Form 3160-5
(June 2019)UNITED STATES
DEPARTMENT OF THE INTERIOR
BUREAU OF LAND MANAGEMENTFORM APPROVED
OMB No. 1004-0137
Expires: October 31, 2021**SUNDRY NOTICES AND REPORTS ON WELLS**
***Do not use this form for proposals to drill or to re-enter an
abandoned well. Use Form 3160-3 (APD) for such proposals.***5. Lease Serial No. **NMSF078630A**

8. Well Name and No. **FOSTER RIDDLE/6**9. API Well No. **3004505420**10. Field and Pool or Exploratory Area
BALLARD PICTURED CLIFFS/BALLARD PICTURED C11. Country or Parish, State
SAN JUAN/NM**12. CHECK THE APPROPRIATE BOX(ES) TO INDICATE NATURE OF NOTICE, REPORT OR OTHER DATA**

Benson-Montin-Greer Drilling Corp. plans to permanently plug and abandon Foster Riddle #6 due to sub-economic production. Please see attached procedure and wellbore diagrams.

BLM FLUID MINERALS P&A Geologic Report

Foster Riddle #6 Proposed P&A

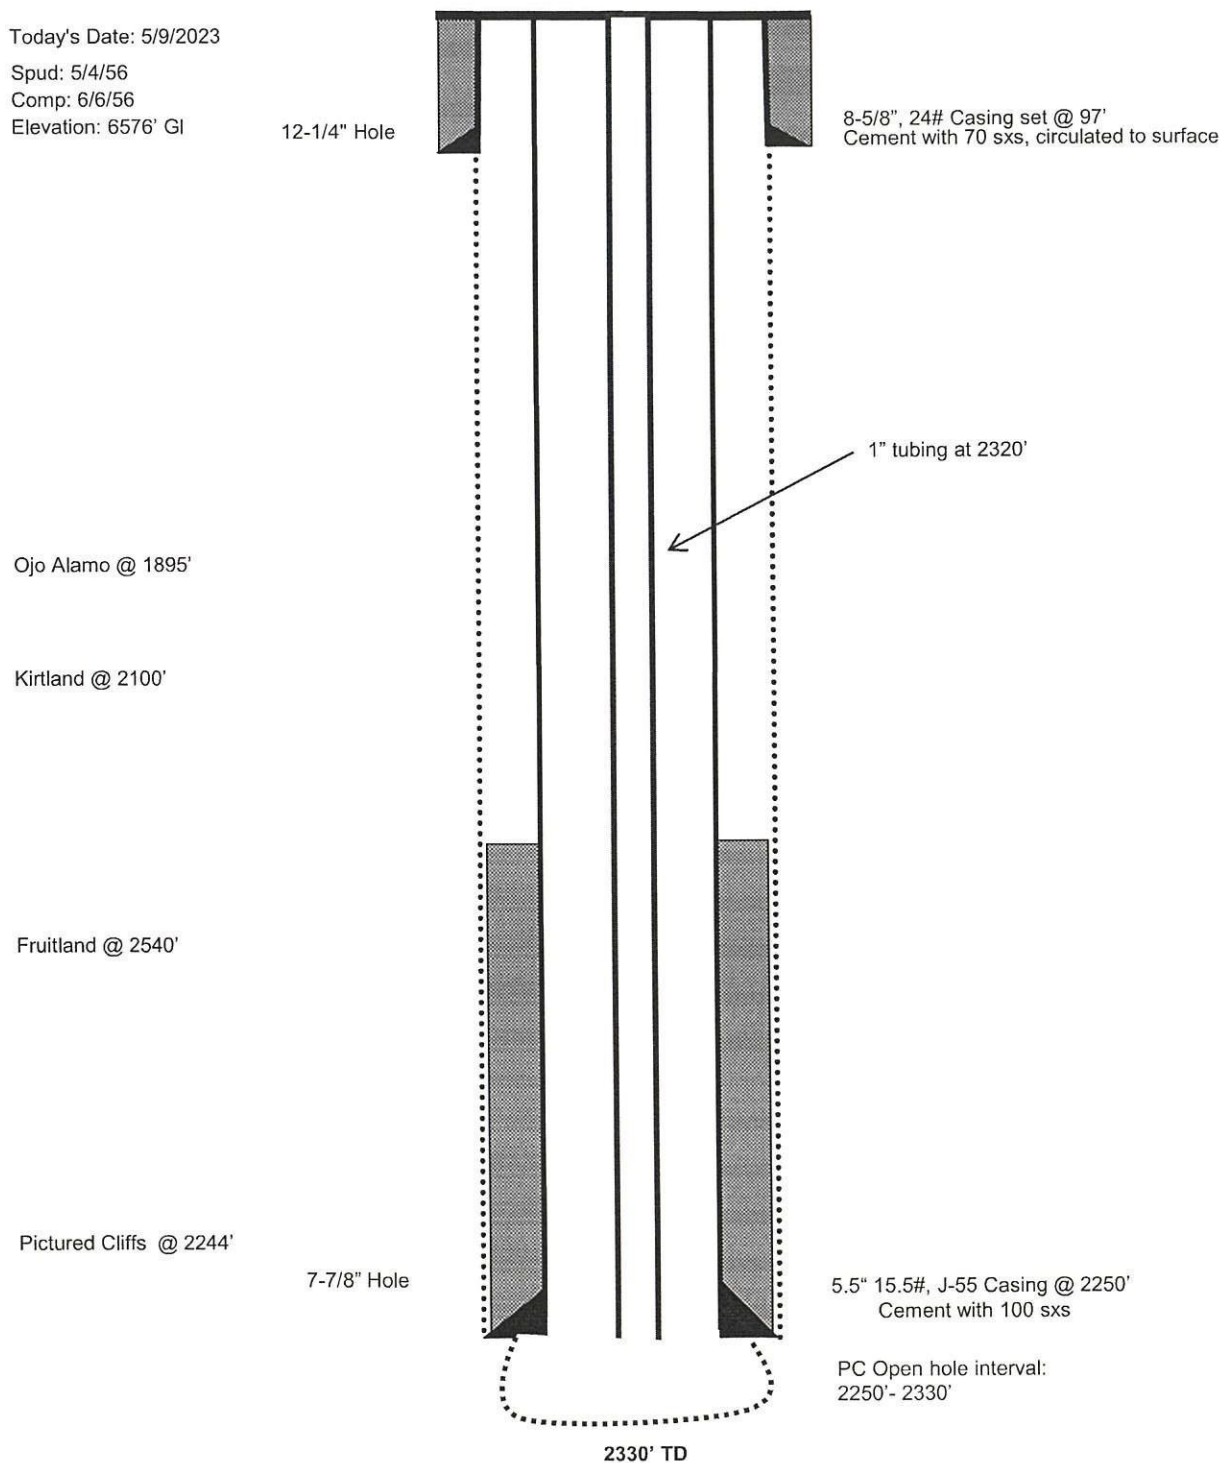
- No well log available for subject well.
- BLM estimate for the Kirtland formation top varies from Operator.
- Bring the bottom of Plug #2 (Kirtland/Ojo Alamo) down to 1754' to cover BLM estimate for the Kirtland formation top (1704').
- No reclamation plan on file. Operator is required to schedule a pre-reclamation onsite with BLM surface staff prior to submitting a reclamation plan for review and approval. Final reclamation earthwork must be completed within 6 months of well plugging.
- Pictured Cliffs open hole completion 2250' – 2330'.
